TRC AGENDA

**CITY OF DELAND
THURSDAY JULY 20, 2023 AT 1:30 P.M.
CITY OF DELAND TRC MEETING ROOM
DELAND, FLORIDA**

City of DeLand
SP23-068
HILLPOINTE DELAND

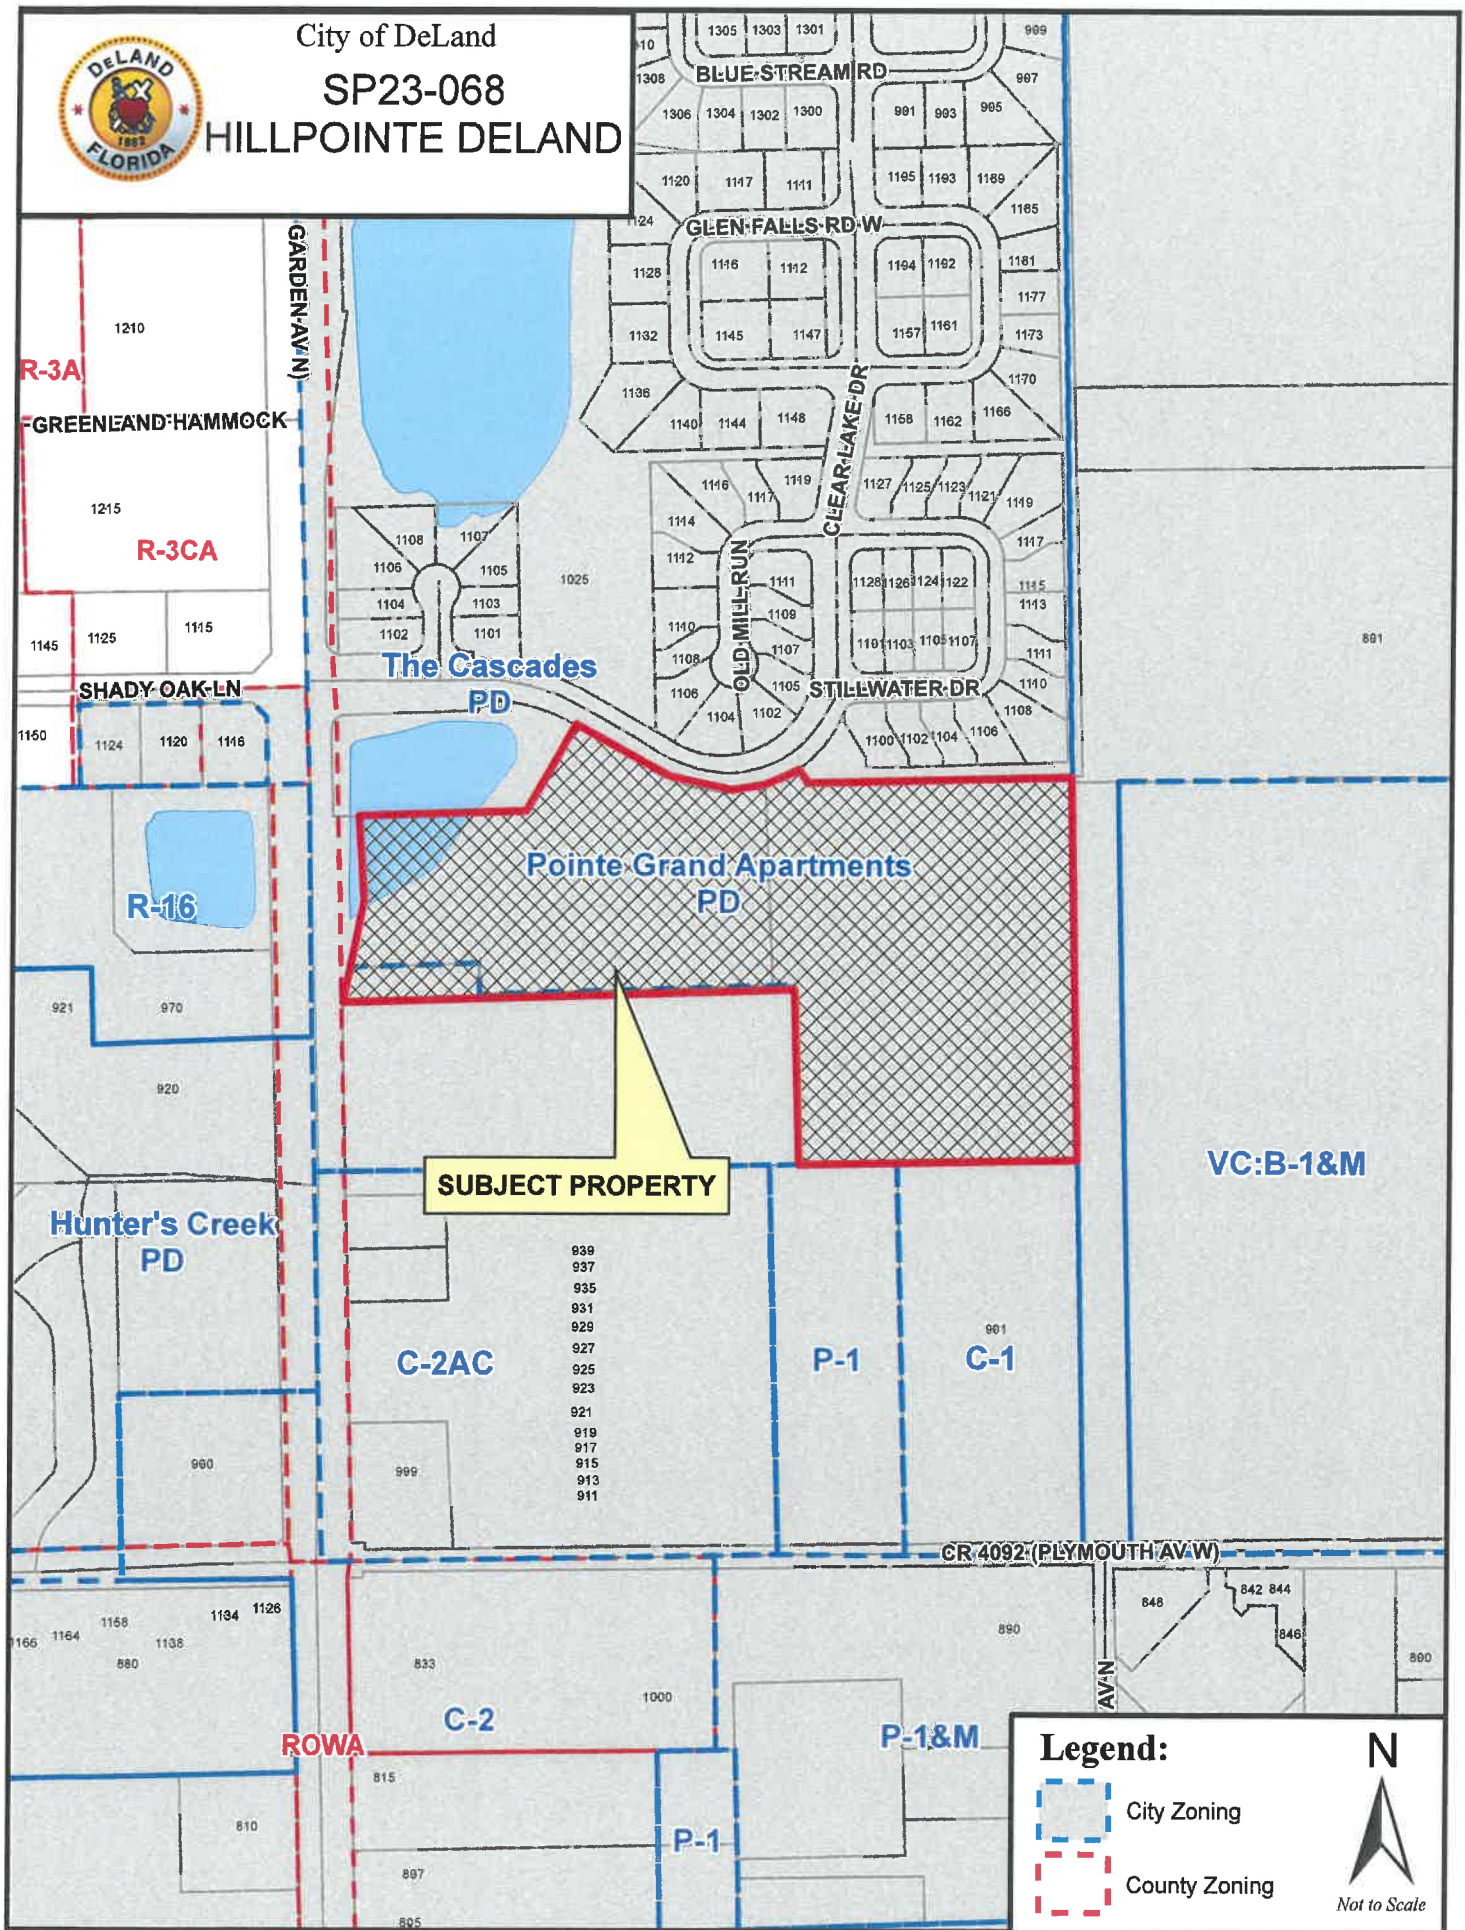
Discipline	Status	Details	Attached To	Created By	Last Updated By	Modifications Required
Matchline						
Engineering	Draft	Matchline should refer to Sheet 5.0 rather than 8.0.	C5.1	Ray Bahrami	Ray Bahrami	Yes
Matchline						
Engineering	Draft	Matchline should refer to Sheet 5.1 rather than 6.1.	C5.0	Ray Bahrami	Ray Bahrami	Yes
Reference to State Coordinate System						
Engineering	Draft	Please update as-built requirements notes to "State Plane East Coordinate System" and not west.	C2.0	Ray Bahrami	Ray Bahrami	Yes
Deteriorated Trees						
Forestry	Draft	Please show the tree ID number for each of the trees in the Deteriorated Trees chart.	A-204	Kit Dennis	Kit Dennis	Yes
Poor Laurel oaks						
Forestry	Draft	Some are mitigated at 1/2 DBH and some 1/3 DBH. Please change all to 1/3 unless the Laurel oak is 20" DBH or greater and the arborist report indicates that it is eligible for reduced replacement. In that case, change the mitigation to 2".	A-204	Kit Dennis	Kit Dennis	Yes

Forestry	Not Accepted		A-202	Mariellen Calabro	Kit Dennis	Yes
Tree Protection Areas Change all Tree Preservation Areas to Tree Protection Areas to be consistent with Code language. Last comment from reviewer: Change "Tree Preservation Area Provided" to "Tree Protection Area Provided" in the Tree Protection Table. Last response: Labeling has been corrected.						
Forestry	Not Accepted		A-202	Mariellen Calabro	Kit Dennis	Yes
Tree Replacement Provided With the suggested revisions, 892" DBH of tree replacement would be provided. Last comment from reviewer: The plant schedule has a total of 845" DBH being planted. Last response: updated						
Forestry	Not Accepted		L-001	Mariellen Calabro	Kit Dennis	No
Forestry	Not Accepted	Tree ID 1015 Tree 1015 is missing from sheet L-101 and is not listed in any of the tree calculation lists. Please make the appropriate correction to whichever sheets need to be corrected. Last comment from reviewer: Please add this to the existing trees to be saved and	C3.0	Kit Dennis	Kit Dennis	Yes

parking count is off						
Planning	Draft	I only counted 472 spaces total. Included in that count are 11 handicap spaces, not 10 as noted on plan. Total should be 510.	C4.0	Kendall Story	Kendall Story	Yes
Traffic Safety Concern						
Planning	Not Accepted	The current configuration of Clear Lake Drive/SR 15A intersection is very wide and open, which leaves multiple areas for traffic to stop while trying to yield to oncoming traffic. The north terminus of the concrete median, on the southside, is ~75-feet from the intersection's center point. Per Google Earth images, FDOT recently updated the intersection's striping, which has likely improved operations by delineating the intersection's center area where motorists are supposed to queue while waiting to make left turns onto SR 15A. Since the project's driveway is Right-in, Right-out, the motorists leaving the site will have to travel north and make U-turns, using the northbound left turn lane at the Clear Lake Drive intersection, to be able to travel southbound on SR 15A. The project is forecasted to generate an additional 35 U-turns in the AM peak-hour and 18 in the PM peak-hour. Due to the wide configuration and the location of the concrete median, city staff has concerns that the project + background U-turns (Total: 39 AM Peak Hour, 28 PM Peak Hour) will occur where the concrete median terminates instead of at/near the intersection's center point. If this occurs, there would be two separate turning movements within the same intersection occurring within 75-feet of one another on a high-speed, higher volume truck route. This is cause for concern that the current configuration may not be safe. Please coordinate with FDOT and provide written documentation stating FDOT does not have concerns with the high number of U-turns occurring at the intersection as it's currently configured.	T0	Melissa Winsett	Kendall Story	Yes

B. HCS Analysis: SR 15A/Plymouth Ave intersection: Please revise HCS input values and check the existing and proposed condition approach volumes. AM Peak-Hour: NB Thru existing volume is shown as 158 while the projected is 828.				
Last comment from reviewer: Repeat comment.						
Last response: tree 1015 is a 15" sabal palm and is not included in mitigation figures						
Combine 4 Parcels						
Planning	Not Accepted	Parcels must be combined. An application for combining property is done online using the Citizen Portal.	T0	Kendall Story	Kendall Story	Yes
		Last comment from reviewer: "Not Accepted" until this is done.				
Last response: Noted. This will be completed.

City of DeLand
PSB23-086
CRESSWIND
PHASE 2 & 3

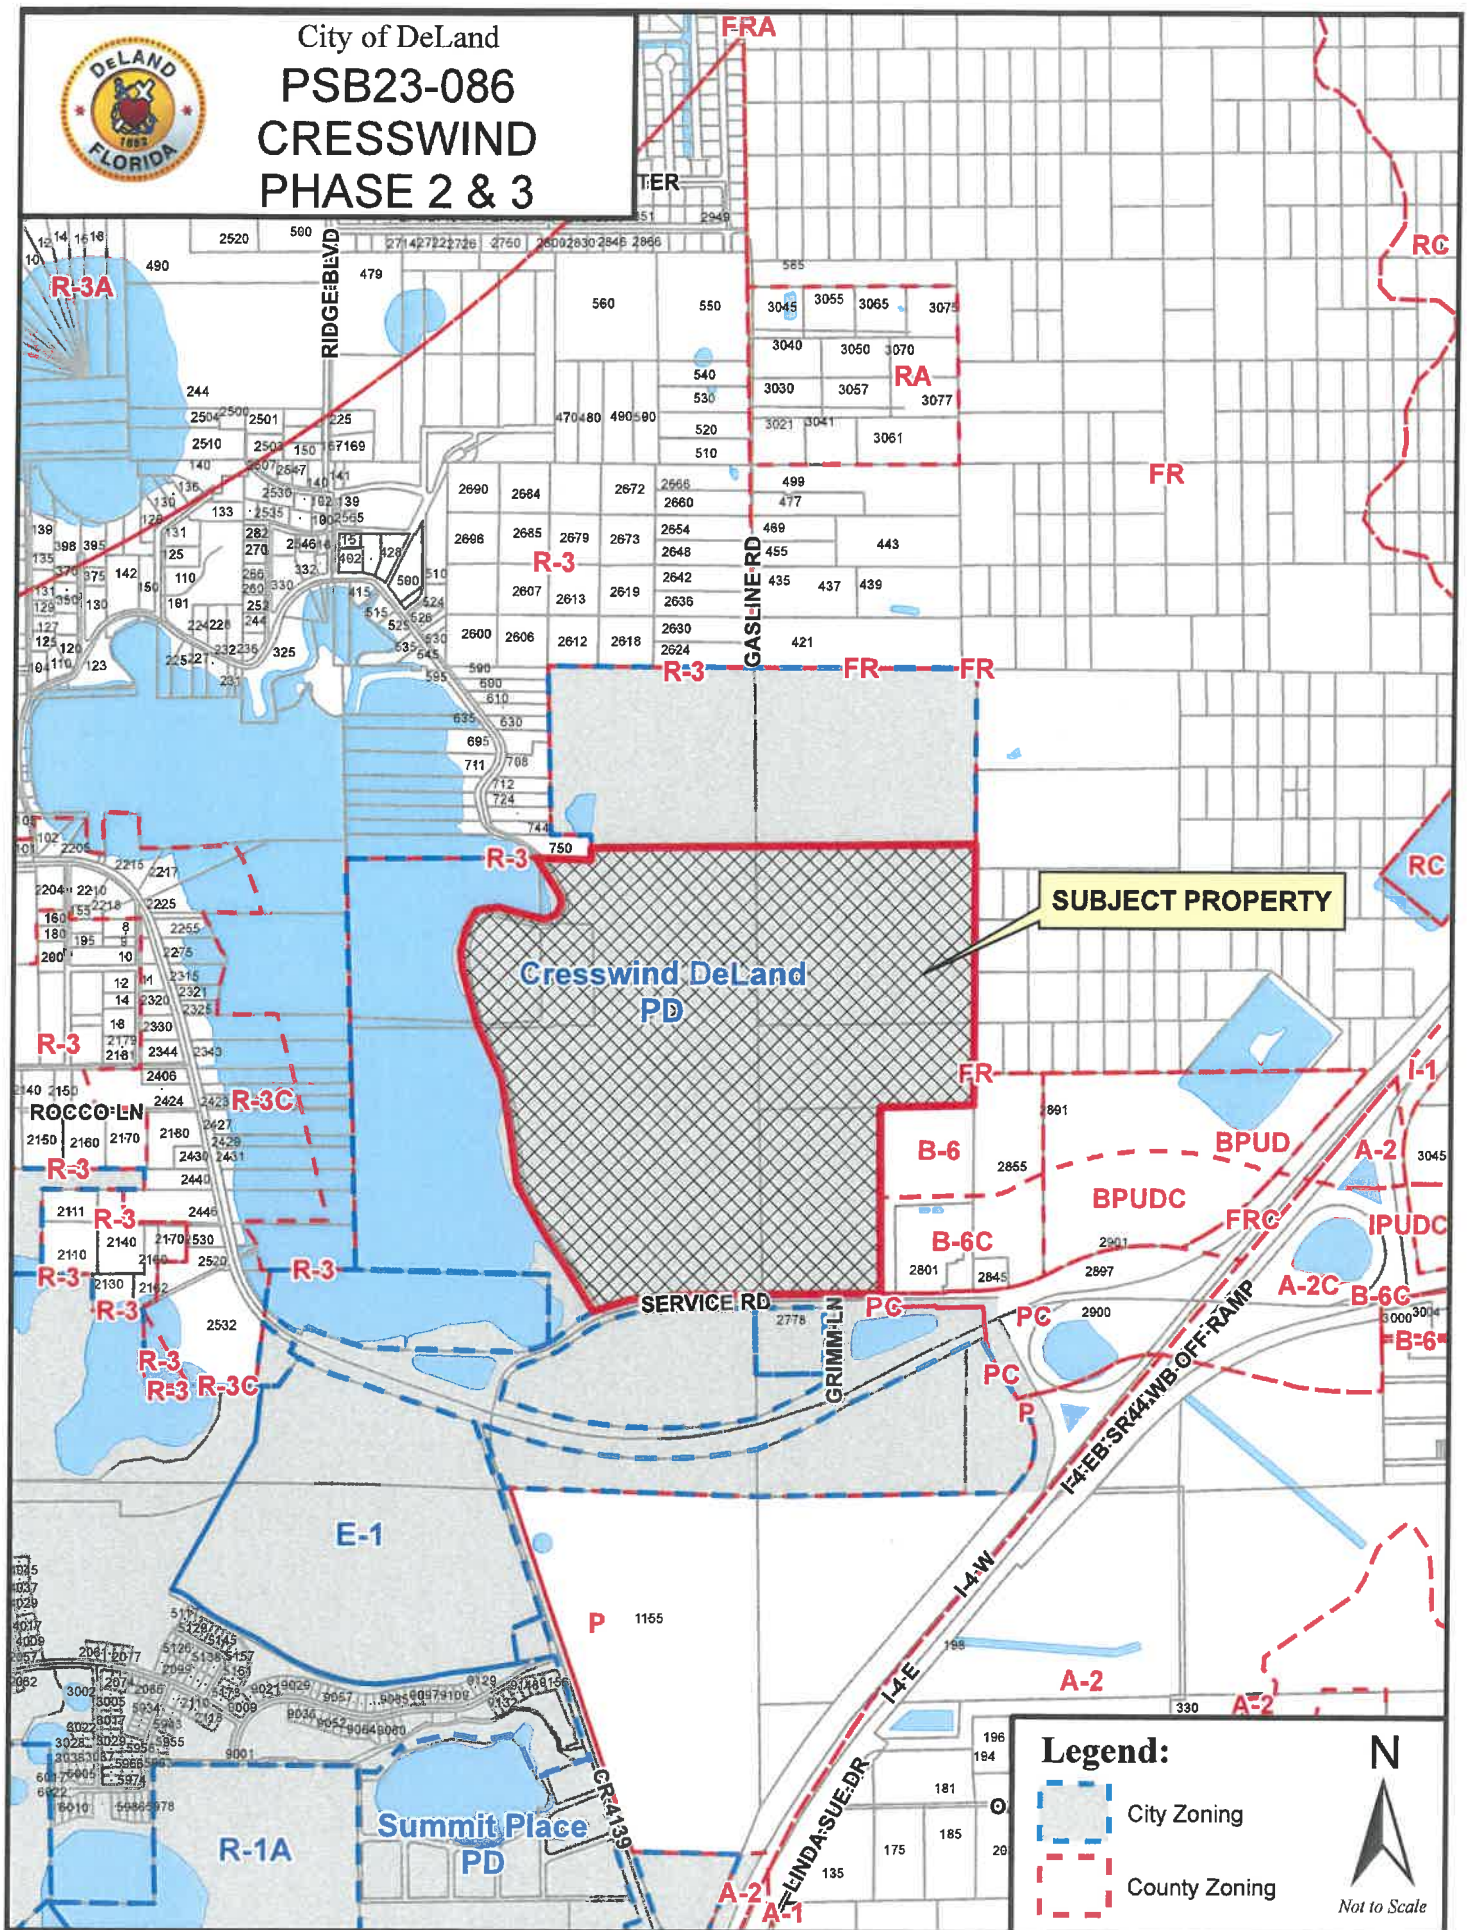
Discipline	Status	Details	Attached To	Created By	Last Updated By	Modifications Required
Engineering	Not Accepted	Master Drainage Stormwater System Analysis 1. Page 3, Floodplain Impacts: There are two Floodplain Ponds proposed for this development. Please provide calculations to show how they were sized and BFEs established. 2. Are Curve Number (CN) calculations in ICPR based on 75% maximum lot impervious area? 3. Do Ponds 3 and 4 have a bleed down structure/orifice proposed per SJRWMD requirement? Last comment from reviewer: 1. Please provide an exhibit which shows Phases 1, 2 and 3 Development with FIRM in the background and BFE. 2. Sheet C-106 Table shows 75% Maximum Lot Impervious and 50% Maximum Project Impervious. Do Curve Numbers used in ICPR reflect that? Last response: 1. Response: Please note Floodplain Pond 1 (node LW-FPM01) is part of the previously approved Phase 1 design and Floodplain Pond 2 (node LW-09) is proposed with the Phase 2 development. As shown on the FEMA map within the previously provided Drainage Report (Appendix A; Page 20), both of the ponds are located within Zone A floodplain limits. Both ponds are sized to ensure no adverse impacts to downstream properties due to the proposed encroachment from both Phases 1 and 2. As shown in the 100-Yr, 24-Hr Discharge & Peak Summary Table within the previously provided Drainage Report (Appendix D; Page 159), nodes LW-04 and LW-08 have 100-year stages lower in the post-development condition than in the pre-development condition. Stage-Areas can be found in Appendix C Proposed Conditions Model (pages 107 & 108) for additional information. Also, BFE's have been added to the Grading & Drainage sheets for all floodplain pond and wetland areas. 2. Response: The CN's that were previously approved within the Phase 1 development have been carried over to the Phase 2 design. The CN's used are based on the Florida Land Use Cover Classification System (FLUCCS) and appropriately defined for the proposed development as shown on the Post-Development Land Use Map in the previously provided Drainage Report (Appendix A; page 18). All proposed development uses a 1300-High Density Residential land use cover for the single-family areas and an 8100-Transportation land use cover for all Right-Of-Way areas. For type A soils, as shown in the Soils Map within the previously provided Drainage Report (Appendix A; page 11), these land uses have CN values of 77 and 81, respectively, and are consistent with all previous approvals. 3. Response: Pond 3 and Pond 4 both have bleed-down orifices sized per SJRWMD	Ray Bahrami	Ray Bahrami	Yes

Tree Deficit						
If your deficit is 21,742, your contribution to the Tree Replacement Reserve Account would be \$1,630,650. Additional planting is recommended.						
Forestry	Not Accepted	Last comment from reviewer: Based on this review, your deficit would be 21,617" DBH which would require a contribution of \$1,621,275 if no additional trees are planted.	L-200A	Mariellen Calabro	Mariellen Calabro	Yes
Last response: Response: It is understood that the plan is deficient. Like the other phases, there will be additional trees added in the future and money paid into the tree account.						
Forestry	Not Accepted	Minimum Coverage and Tree Protection Area Requirements If the project area is 77.77 acres, 11.7 acres of TPA will be needed and 8,130" DBH will be needed to meet minimum coverage requirements. Last comment from reviewer: At what phase will these requirements be met? We are three phases in, and all have been deficient. Please provide a timeline for addressing the deficiencies. Last response: Response: It is understood that the plan is deficient. Like the other phases, there will be additional trees added in the future and money paid into the tree account. In each phase there is a deficiency in the tree protection requirement. As the enhanced plans and future phase landscape plans are finalized, there will be additional inches/trees added to the plans to comply with the minimum coverage requirements.	C-100	Mariellen Calabro	Mariellen Calabro	Yes

Sheet L-400A shows the total acreage of Phase 2 and 3 as having 89.08 acres, yet the survey shows it has 79.324 acres. Please clarify this discrepancy and revise on all sheets as well as recalculate data.				
Planning	Not Accepted	Last comment from reviewer: Minor: Please add a note on the plan to identify and explain the discrepancy as articulated in the applicant's response.	L-400A	Melissa Winsett	Melissa Winsett	Yes
		Last response: Response: There is a discrepancy due to the difference in the boundary lines and phase lines. The survey calculates the acreage per the boundary line and the landscape sheet acreage is calculated per the phase lines. This is ok that it is a different number. All area are accounted for within this plan set.				
		"Phase 2-3 Boundary Site Data and Open Space Calculations" Table:				
Planning	Not Accepted	A. The "Phase 2-3 Boundary Site Data and Open Space Calculations" table includes inconsistent data and descriptions, which makes verification difficult. Please compare this table with the table on Sheet L-100. The "descriptions" should have matching and consistent data. For example, Sheet L-400A's table shows the "Open Space Area" as having 17.94 acres, yet L-100's table shows "Other Open Space (Phase 2-3 Plat)" as having 1.8 acres. Instead, expand the table to break out the subcomponents that make up their "Descriptions." Per city staff's review, the combined acreages of Phase 2&3's Net Wetland Conservation, Wetland Setbacks, Other Open Space, and Utility Easement totals 17.4 acres, which is close to the 17.94 acres shown in the L-400A table. However, the numbers are off and the data used in the table not accurate and consistent. Please revise either sheet, or both, to be consistent (use exact numbers) – especially due to the note below the respective table that directs readers to "See Sheet L-100 for Overall Site Data and Open space Calculations Chart." As previously mentioned, the table's information should be transparent enough for the public to understand. Note: City staff's review of Sheet L-100 found the data to be consistent to the data within the PD's development agreement. B. Please document sources and/or explain the table's descriptions. For example, "Future Development" is shown as having 1.76 acres. Considering that the application is for Phases II and III, please explain why 1.76 acres of "Future Development" is shown within those respective phases. Also explain how the acreage was computed for areas like ROW area, Utility Easement, and any item that isn't in the table on sheet L-100). Expand the table and use footnotes to show where the acreage calculations are located elsewhere in the plan. The reader should be able to go back and forth between the plan sheets to understand the acreages and verify the percentages. Last comment from reviewer: The Site Data and Open Space calculations are sufficient and fairly similar to staff's calculations; however, they are very difficult to review	L-400A	Melissa Winsett	Melissa Winsett	Yes

Clarification Statements						
Planning	Not Accepted	A. Add a statement identifying that the plan is for Phases II and III (total of 223 single family homes) with Cresswind Planned Development age-restricted community. B. Please explain whether both phases are planned to be concurrently constructed. The city does not want both phases cleared if the intent is to only submit a final plat for one of the two phases. Last comment from reviewer: Regarding the Response to Comment B and the city's stated desire, please add a statement on the plan that commits the applicant from clearing both phases concurrently if both phases aren't being constructed concurrently. Last response: A. Response: We have added a qualifier to the project name on sheet C-100 that says "(A Kolter Age Restricted Community)". B. Response: The intent is to build both phases, however the order of construction has not yet been determined.	C-100	Melissa Winsett	Melissa Winsett	Yes
